Docket Nos. 50-3  
and 50-247

The Commission has issued the enclosed Amendment No.35 to Facility Operating License No. DPR-5 and Amendment No.106 to Facility Operating License No. DPR-26 for the Indian Point Nuclear Generating Unit Nos. 1 and 2. The amendments consist of changes to the Technical Specifications in response to your application transmitted by letter dated June 18, 1985. This amendment relates to only one of several subjects contained in the June 18, 1985 submittal. The other topics will be the subject of separate licensing actions.

SUPPORTING AMENDMENT NO. 35 TO PROVISIONAL OPERATING LICENSE NOS. DPR-5 AND  
AMENDMENT NO. 106 TO FACILITY OPERATING LICENSE NO. DPR-26

INDIAN POINT NUCLEAR GENERATING STATION UNITS 1 AND 2

Figure 3.1 Facility Management and Technical Support Organization

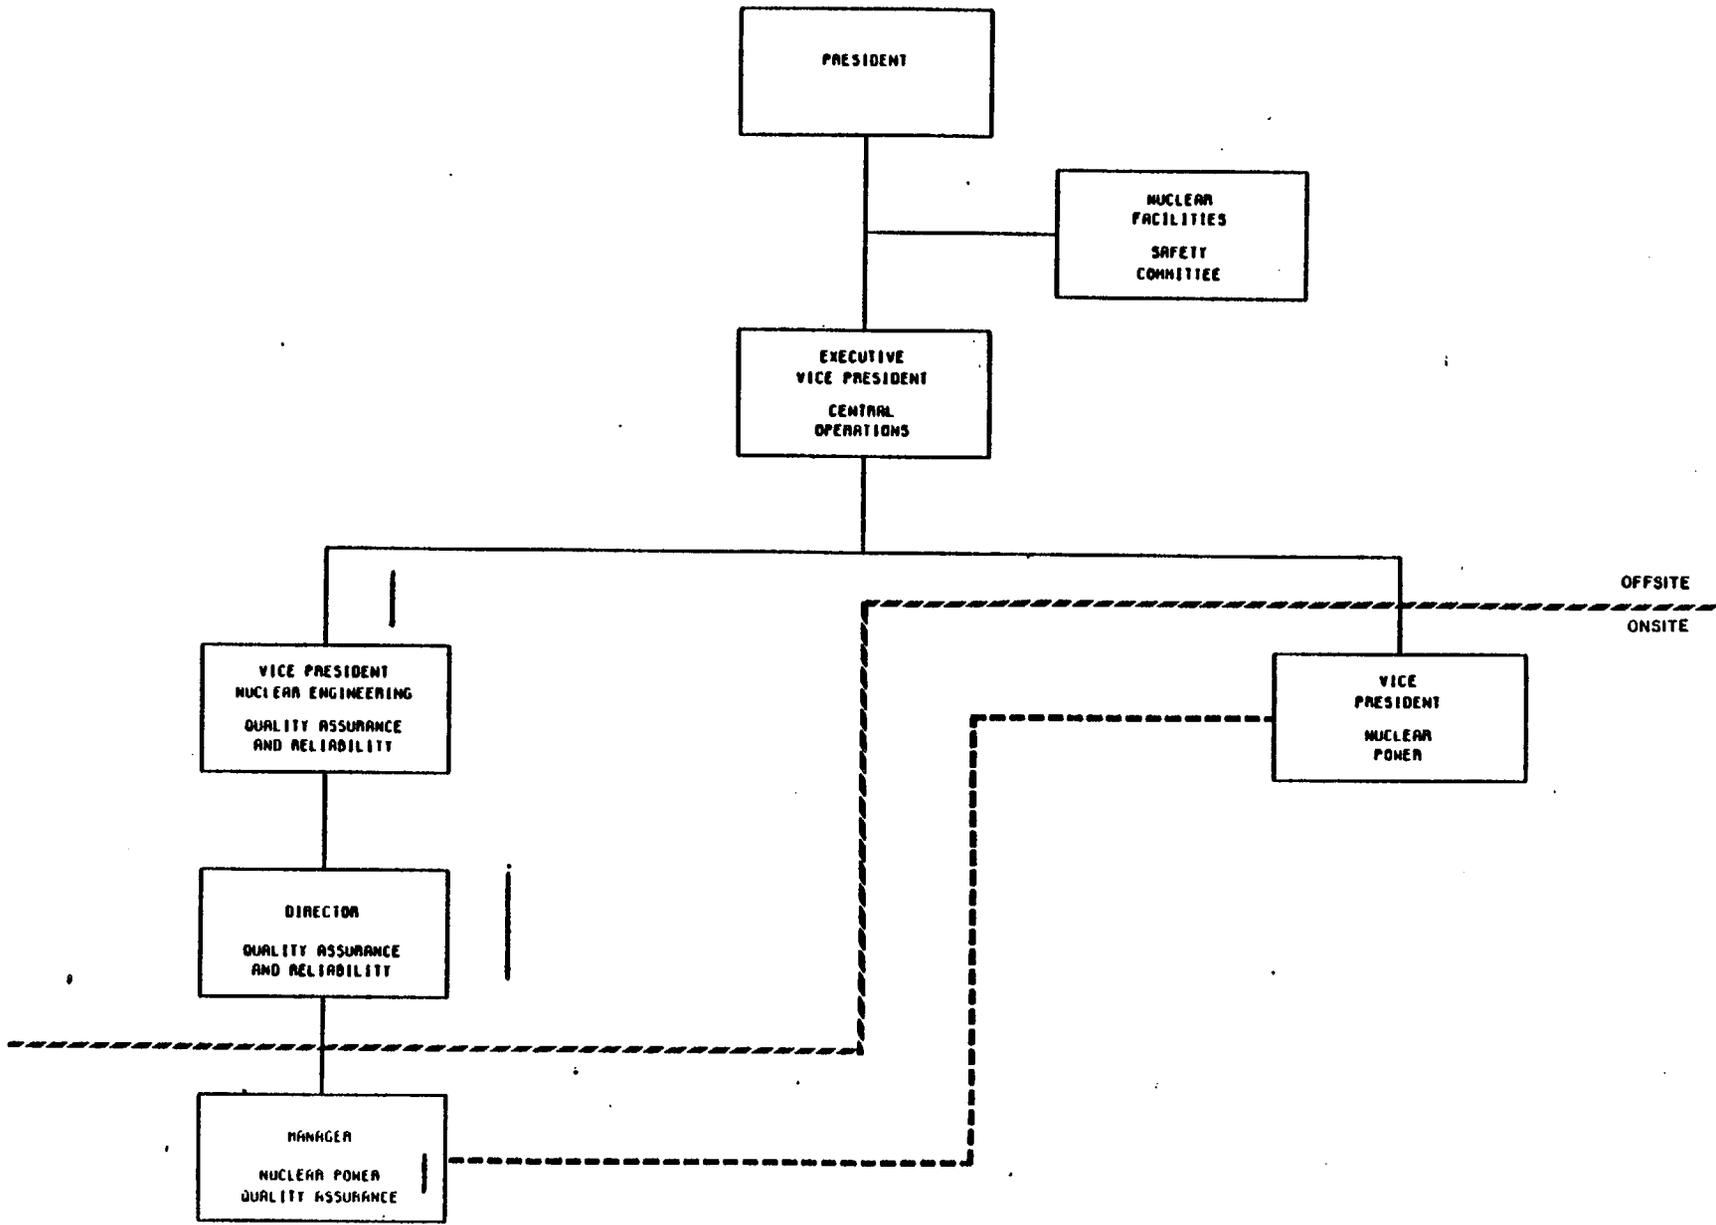
The amendments revise Figure 3.1 of the Indian Point Unit No. 1 Technical Specifications and Figure 6.2-1 of the Indian Point Unit No. 2 Technical Specifications to reflect organizational changes realigning the offsite technical and management support groups and reporting whereby the Vice President of Nuclear Engineering Quality Assurance and Reliability answers directly to the Executive Vice President of Central Operations.

Currently, the Technical Specifications (TSs) Figures 3.1 and 6.2-1 (Units 1 and 2 respectively) depict the Vice President of Nuclear Engineering and Quality Assurance (VP-NEQA) and the Site QA Manager to be independent from the Vice President of Nuclear Power. The proposed revisions provide more details on the quality assurance organization and reflect an organizational realignment where the Vice President Nuclear Engineering Quality Assurance and Reliability (new title for the VP-NEQA) reports to the Executive Vice President of Central Operations. This organizational change was made to provide more direct communication between the offsite organization and the station to facilitate better technical and management support for the station.

The quality assurance organization is further strengthened by adding a Director of Quality Assurance and Reliability at the corporate level. This change maintains the independence of the quality assurance organization from those responsible for operating, maintaining and providing other technical support to
